ADDENDUM #1

Pre-Bid Meeting Questions

PHILLIPS CREEK RANCH - STEP GRANT PROPOSAL SHEET

Project Number: STP 2011 (233) TE

SHEET 08-03A

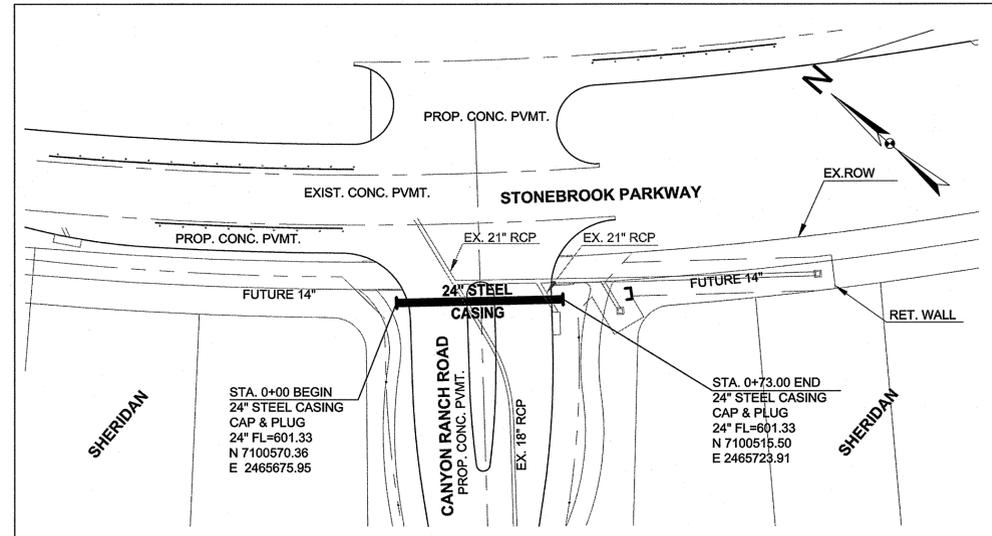
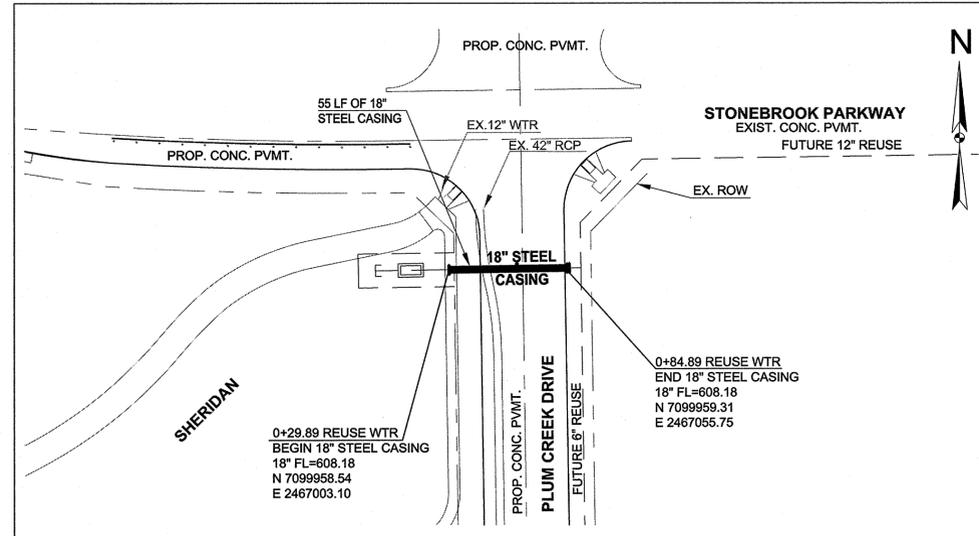
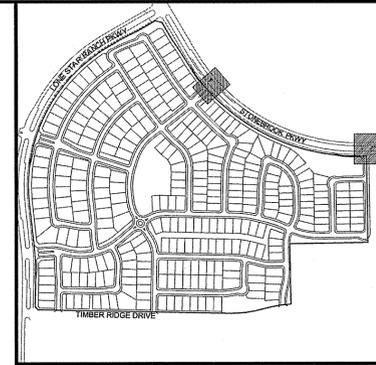
10. **Note existing paving at Lone Star Ranch Parkway, directly south of the intersection with Stonebrook Parkway will require a 14" bore for irrigation mainline.**
11. **An existing 24" casing has already been provided under Canyon Ranch Road for the irrigation mainline. Ref. 2/LI 3.2**
